Economic Commission for Europe**Inland Transport Committee****World Forum for Harmonization of Vehicle Regulations****Working Party on Passive Safety****Seventieth session**

UN Regulation No. 136 (Electric vehicle L)**Proposal for the 01 series of amendments to UN Regulation No. 136 (specific requirements for the electric power train of vehicles of category L)****Submitted by the expert from the International Motorcycle Manufacturers Association ***

Arrangements of the approval marks

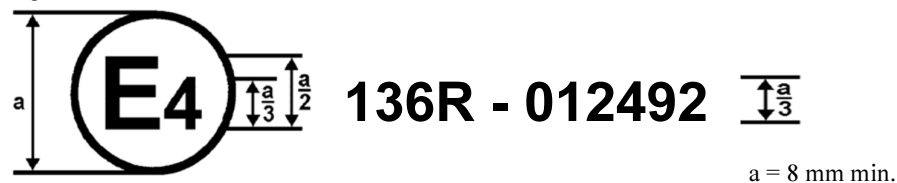
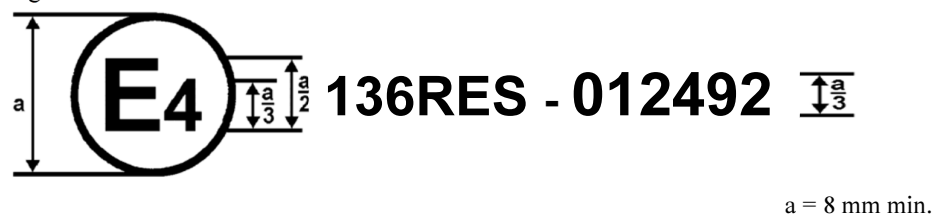
The approval mark in Figure 1 affixed to a vehicle shows that the road vehicle type concerned has been approved in the Netherlands (E 4), pursuant to Regulation No. 136, and under the approval number 012492. The first two digits of the approval number indicate that the approval was granted in accordance with the requirements of UN Regulation No. 136 **as amended by the 01 series of amendments.**

The approval mark in Figure 2 affixed to a REESS shows that the REESS type ("ES") concerned has been approved in the Netherlands (E 4), pursuant to Regulation No. 136, and under the approval number 012492. The first two digits of the approval number indicate that the approval was granted in accordance with the requirements of UN Regulation No. 136 **as amended by the 01 series of amendments**.

Annex 3, paragraphs 2. to 3., amend to read:

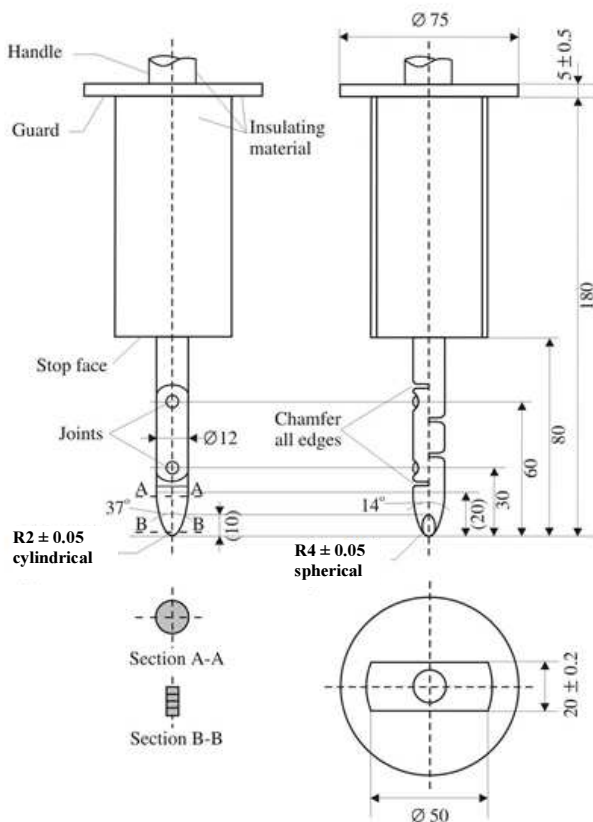
- "2. Test conditions
- The access probe ...
- Internal **electrical protection** barriers are ...
- A low-voltage ... inside the **electrical protection** barrier or enclosure.
- ...
3. Acceptance conditions
- ...
- In ~~the~~ case of the test for **protection degree** IPXXB, the jointed ...
- In case of the tests for **protection degree** IPXXD, the access probe ..."
